SERVICE BULLETIN FUEL FILL HOSE SEAT PLATE INTERFERENCE

Models affected: Collins Bus Models with seats installed over the fuel tank fill hose.

Fuel Fill Hose under bus behind driver's side skirt

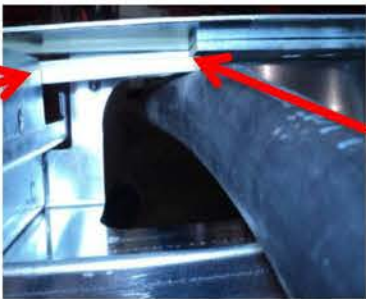
Seat mount plate sharp edge could rub on the fuel fill

If during inspection of the fuel fill hose to the mid-ship fuel tank you find the cut edge of the seat mount plate is directly above the fuel fill hose and making contact, a seat mount plate cover (442290) should be installed.
Remove the seat bolt nut closest to the fuel fill hose.

Slide the plate cover (442290) over the seat mount plate until the holes are aligned. This cover will keep the sharp cut edge on the seat mount plate from making contact with the fuel fill hose.

Replace the seat bolt nut and tighten to 12-14 ft. lbs.
